Technical Service Bulletin

46 Rattling/knocking noises (from the front end of the vehicle) while driving on rough roads

46 22 36 2068446/1 November 7, 2022.

Model(s)	Year	VIN Range	Vehicle-Specific Equipment
Q4 e-tron quattro, and Q4 Sportback etron quattro	2022 – 2023	All	Not Applicable

Figure 1: Brake system, lower brake pad retaining springs

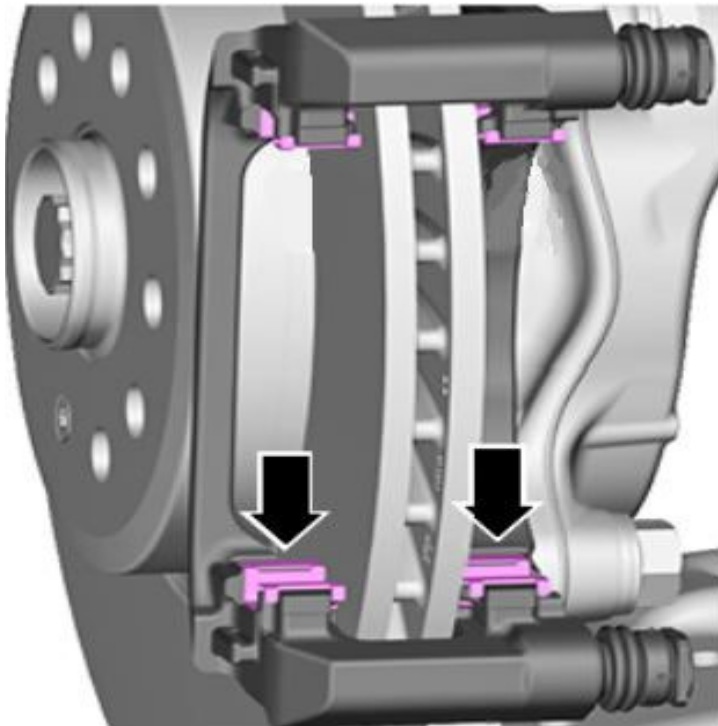
1. Replace lower brake pad retaining springs on the front brake system (left/right) according to *ELSA* > > *Repair Manual* > > *Chassis* > > *Brake System* > > *46 Mechanical Components* > > *Front Brakes* > > *Brake Pads Removing and Installing*.
2. Remove brake pads and brake pad retaining springs (Figure 1, arrows marking) on the front brake system.
3. Clean brake calipers/old brake pads and remove any brake dust using workshop equipment.
4. Install new lower brake pad retaining springs (1EA 615 231B) (Figure 2, red marks) together with old brake pads.

Note: Do not replace the brake pads, old pads should remain in the vehicle.
